DeKalb County Zoning Board of Appeals

Planning Department Staff Analysis

D4. Case No: A-26-1248106

211 S Howard Street - Townhome Development

SITE PLAN

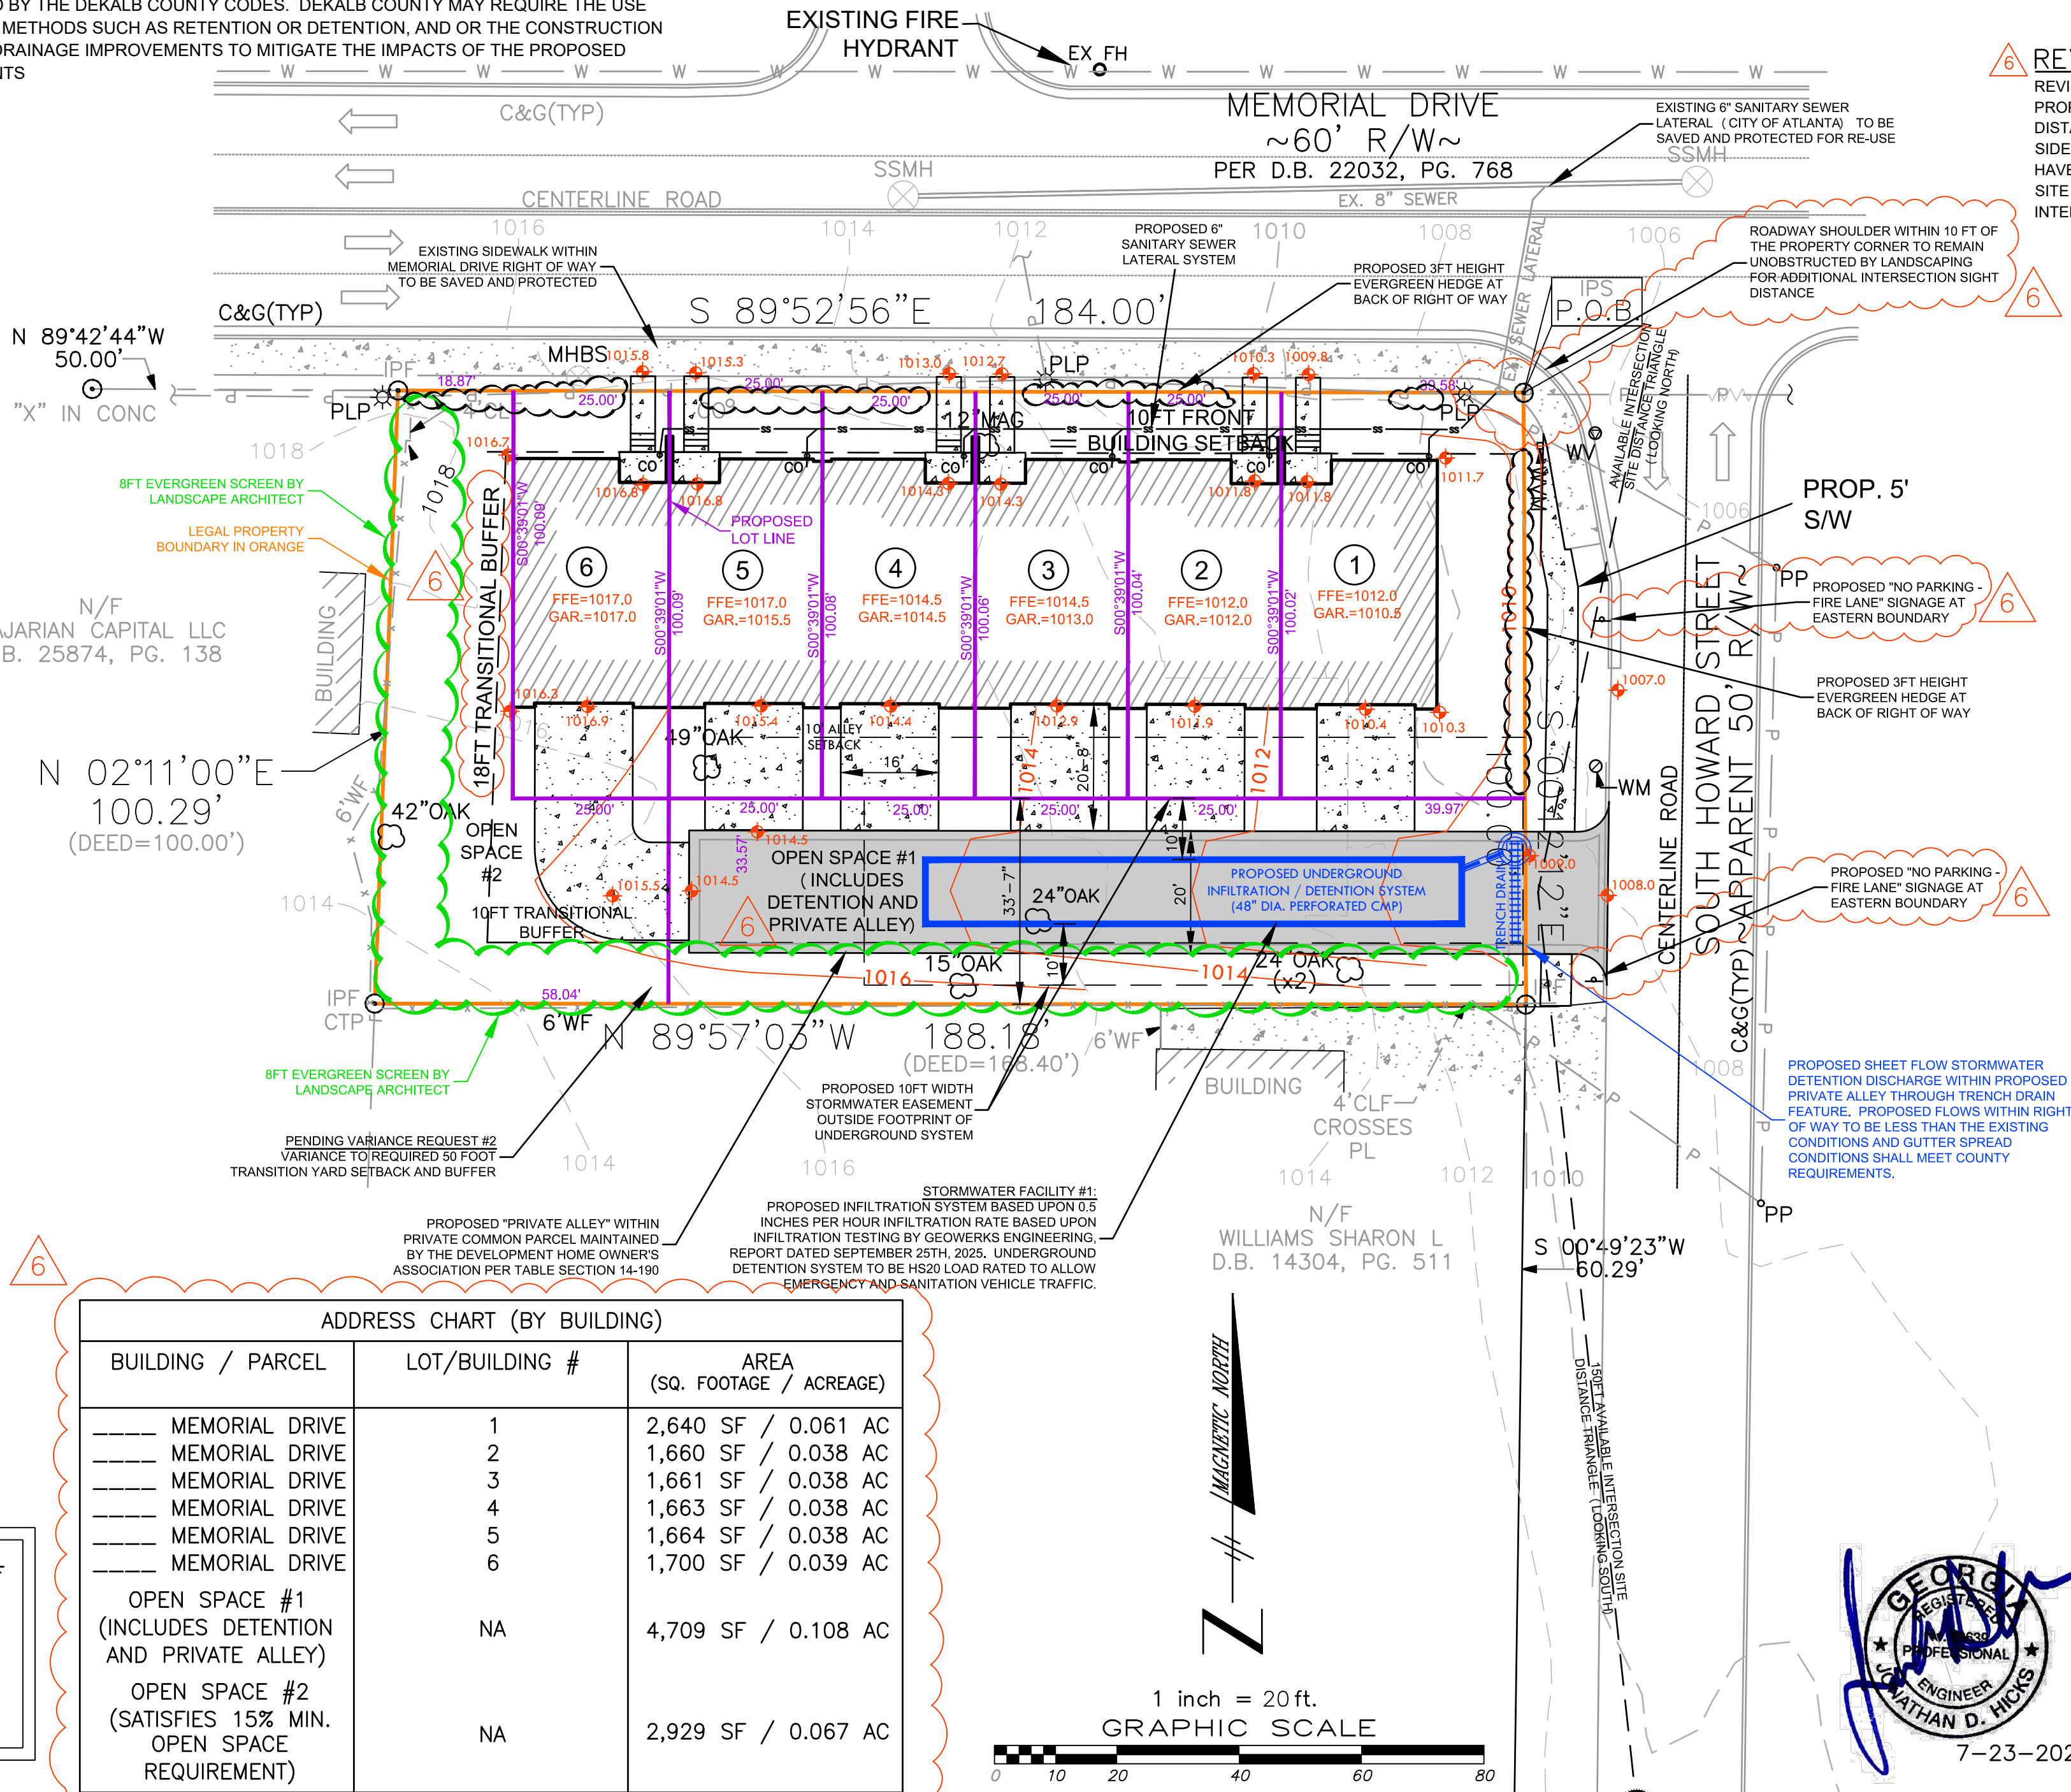
The submitted request appears to go beyond the minimum necessary to afford relief. Staff further acknowledges that strict application of 50-foot buffers along both affected sides of the property would be heavily imposing on a constrained corner-lot site and that some reduction may be necessary to allow reasonable use of the property. However, there may be an opportunity to reduce the extent of the requested variances by reducing the number of proposed units, modifying the site layout, or otherwise revising the development program to better fit the dimensional limitations of the property.

Staff acknowledges that the request has been reduced regarding the southern transitional buffer, however the request regarding the western transitional buffer had been increased by an additional five feet from the previous hearing.

However, the submitted request appears to exceed the minimum relief necessary. While the site may warrant some variance relief, the scale of the requested variances indicate that the proposed development may be over-programmed for the lot. There may be an opportunity to reduce the requested relief through a reduced number of units, revised site design, or a development program that better responds to the property's constraints and the adjacent R-75 single-family residential context.

REVISION #6 DESCRIPTION:

REVISION #6 INCLUDES A 10 FOOT SHIFT WEST OF THE PROPOSED TOWNHOME UNITS TO PROVIDE ADDITIONAL DISTANCE BETWEEN THE UNITS AND THE THE SOUTH HOWARD SIDEWALK. ADDITIONAL LANDSCAPE AND SIGNAGE REVISIONS HAVE BEEN MADE TO ALLOW FOR ADDITIONAL INTERSECTION SITE DISTANCE AT THE SOUTH HOWARD AND MEMORIAL DRIVE INTERSECTION.
